Access Compliance Report

Public Rights-of-Way

(Pedestrian Signals)

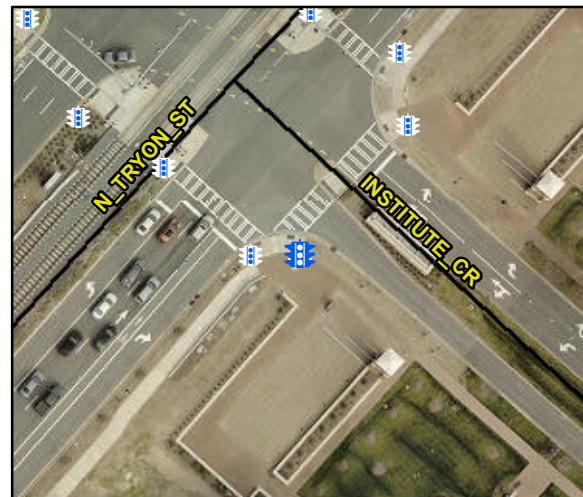
Intersection ID: N/A	Main Street:	Cross Street: N/A	Location: N/A
ADA ID: 5B465F4EF480	Signal Type: One Push Button-APS	Overall Compliance: No	Severity Score: BTN 1: N/A BTN 2: N/A No BTN: N/A
Codes/Mitigation Info/Possible Solution		Field Measurements/Component Compliance

PROW/ADA: TMUTCD 4e.08, R404.2, R404.3, R404.7.2

Possible Solutions: Replace Signal Push Button With APS Button on New Post. Remove & Relocate Sign.
